**Amendments to the Drawings:**

**REMARKS**

FIG.6A

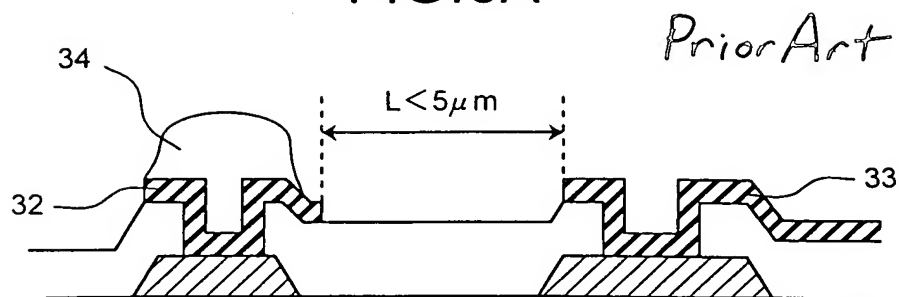
Figures 6A-6C, 10, 11, and 15A-15E have been changed to include the legend "Prior Art."

Claims 1 and 13 include the feature “wherein a distance between the first wire and the second wire is more than or equal to 5 $\mu$ m.” One with ordinary skill in the art in view of the disclosure would interpret this feature to mean that the distance between the first wire and the second wire as claimed is the narrowest distance between them. Even FIG. 6A and the description given on pages 13-14 of the specification, which was relied upon by the PTO, indicate that the distance between the first wire and the second wire is the narrowest distance between them. As depicted in FIG. 6A, the distance measurement taken from the right-side edge of the first wire to the left-side edge of the second wire, which is the narrowest distance between them, is described as the distance between the first wire and the second wire. This distance is clearly less than 5 $\mu$ m since it is so stated in the figure itself where it says  $L < 5\mu\text{m}$ .

In addition, it is noted that FIG. 6A only indicates one dimension, which is the distance indicated as  $L < 5\mu\text{m}$ . FIG. 6A is not drawn to scale and provides no other dimensions in which one with ordinary skill in the art could use to even measure the distance from the left-side edge of the first wire to the right-side edge of the second wire. Thus, even the assertion that the distance from the left-side edge of the first wire to the right-side edge of the second wire is 5 $\mu$ m or greater, as suggested by the PTO, is incorrect because there is not enough information in FIG. 6A or the specification to make such a determination. “[I]t is

FIG.7

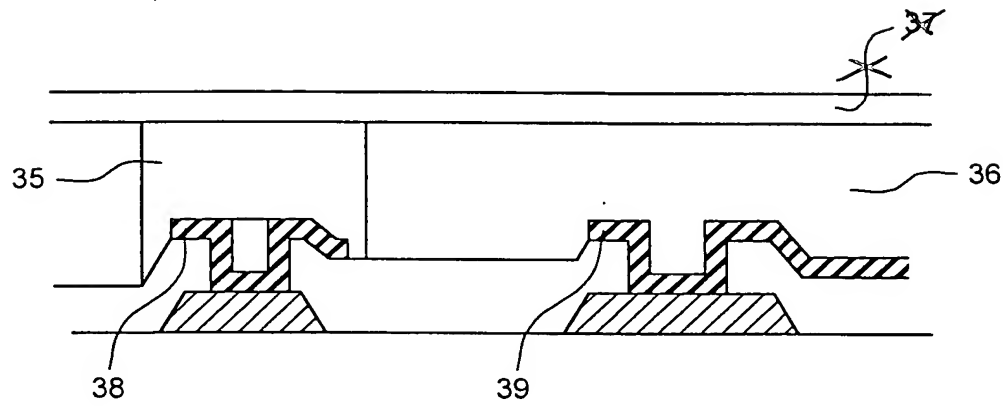
Fig. 7 has been changed to delete the reference numeral "37" from the figure.

FIG.12

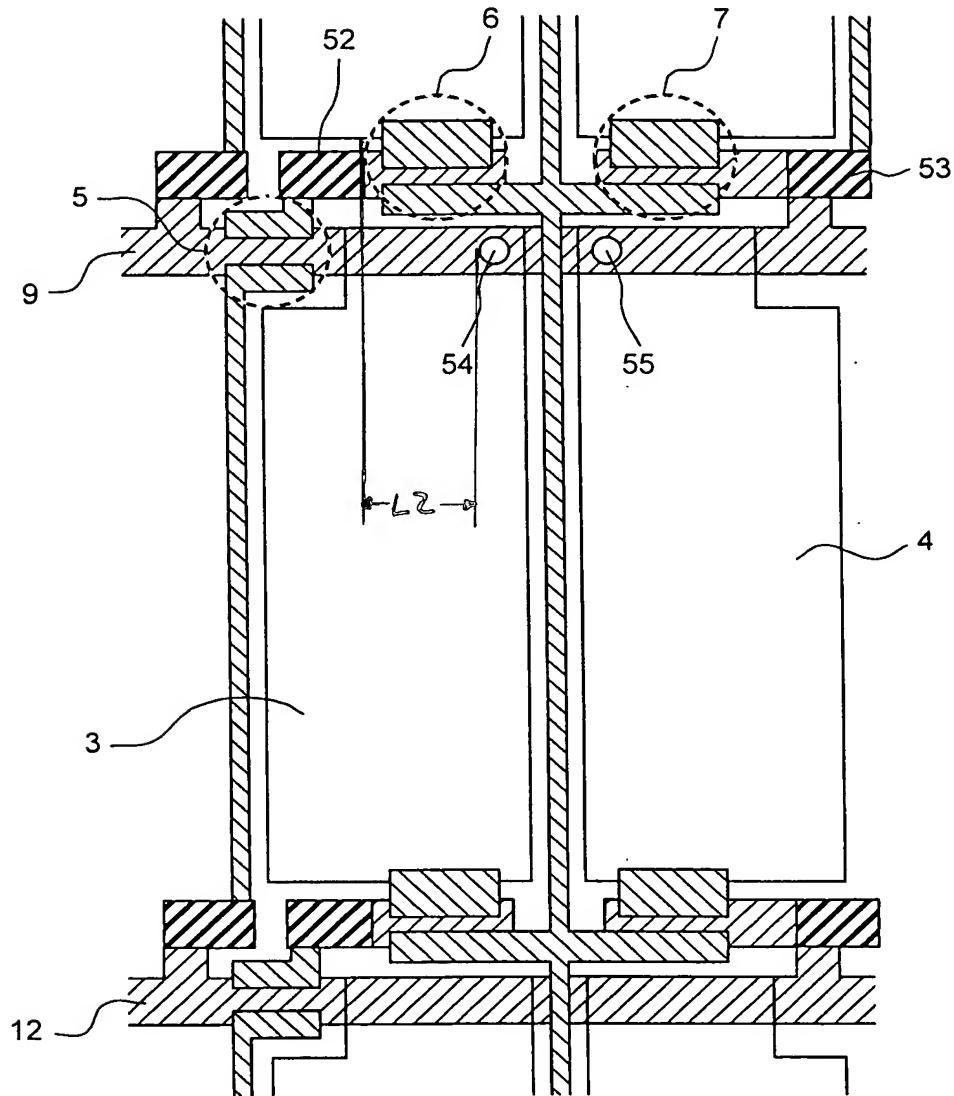
Fig. 12 has been changed to include the character "L2" between the surface wire 52 and the spacer 54, as described in the specification on page 22, lines 15-21.

FIG.15C

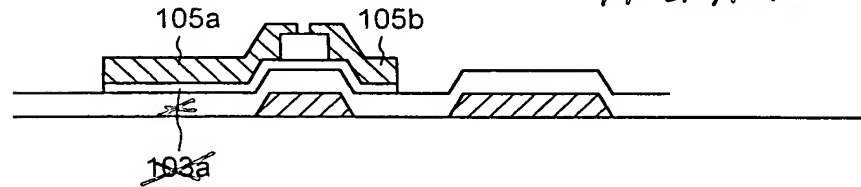
Fig. 15C has been changed to delete the reference numeral "103a" from the figure.
